AMENDMENTS TO THE DRAWINGS

REMARKS

ZHANG, J. et al.
Appl. No. 10/800,014
December 4, 2006

FIGURE 3

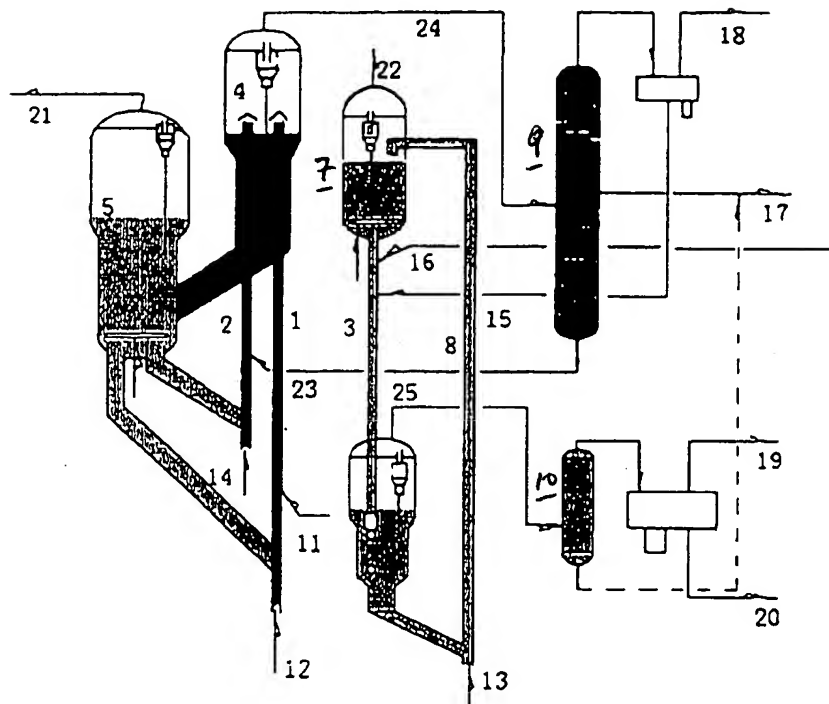
The attached three Replacement sheets of drawings includes changes to Figure 3 indicated in the corresponding attached Annotated Sheet of Figure 3. Specifically, Figure 3 has been revised to include an indication of tanks 7, 9 and 10. No new matter has been added.
